**RE: Supplementary Letter
Major Projects – Request for Advice – 156-166 Rickard Road, Leppington (SSD-84430209)**

SS/2025/6/1 - 156-166 Rickard Road
LEPPINGTON - Mixed-use residential
precinct

A PUBLIC DOMAIN RESPONSE

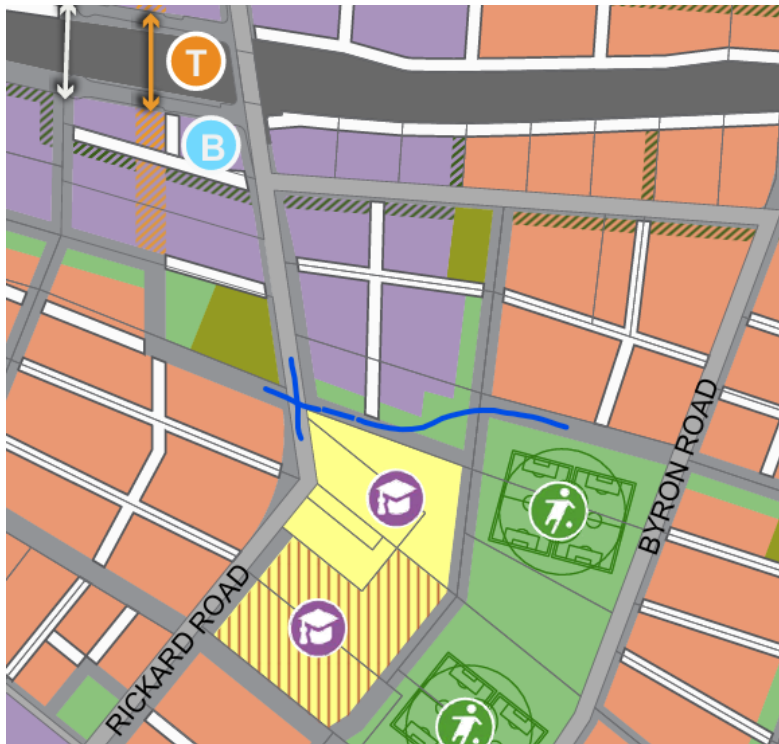
AECOM is in the process of preparing the road alignment as shown by the sketched blue line in the image provided below where the following is critical to be noted:

- Shift the major intersection 1.07 to the south so that robust transport connectivity is provided to the various types of land uses, particularly the school at the heart of Leppington Town Centre, including provision of east-west two-way town centre road connectivity.
- Provide road alignment connecting Rickard Road and Byron Road as shown by the sketched blue line so that 'dog-legged' intersection is removed.

In this regard, the intersection design of road 1 with Rickard Road is not supported and is required to be redesigned.
